Well Name: FEDERAL I

Notice of Intent

Type of Action: Plug and Abandonment

CONDITIONS OF APPROVAL

Proposed P&A

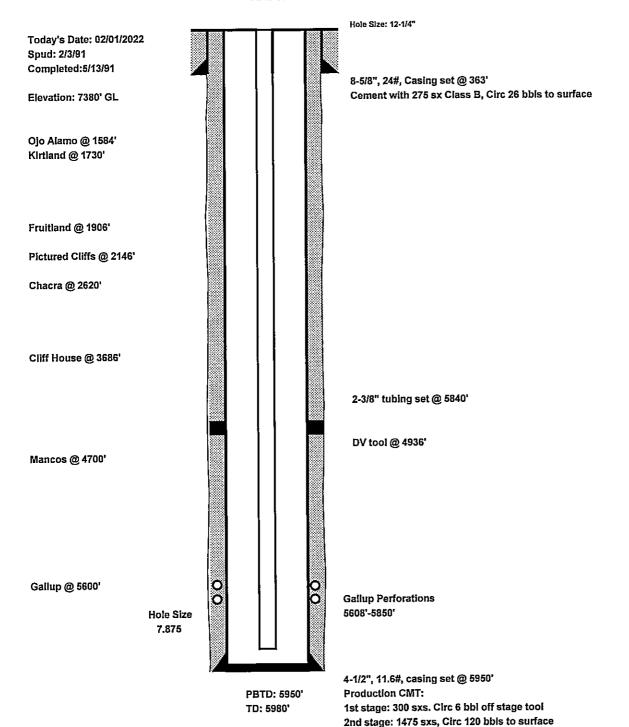
- 1. Plugging operations authorized are subject to the attached "General Requirements for Permanent Abandonment of Wells on Federal and Indian Lease."
- 2. The following modifications to your plugging program are to be made:
 - a. Add a plug to cover the Chacra formation top at 2620'.
 - b. Bring the bottom of Plug #4 (Fruitland and Pictured Cliffs) down to 2268' to cover BLM pick for the Pictured Cliffs top.
- 3. Farmington Office is to be notified at least 24 hours before the plugging operations commence (505) 564-7750.

- BLM picks for the Fruitland and Pictured Cliffs formation tops vary from Operator.
- Add a plug to cover the Chacra formation top at 2620'.
- Bring the bottom of Plug #4 (Fruitland and Pictured Cliffs) down to 2268' to cover BLM pick for the Pictured Cliffs top.
- The plugs proposed in the P&A procedure, with recommended changes, will adequately protect any freshwater sands in this well bore.
- Gallup perfs 5608' 5850'.
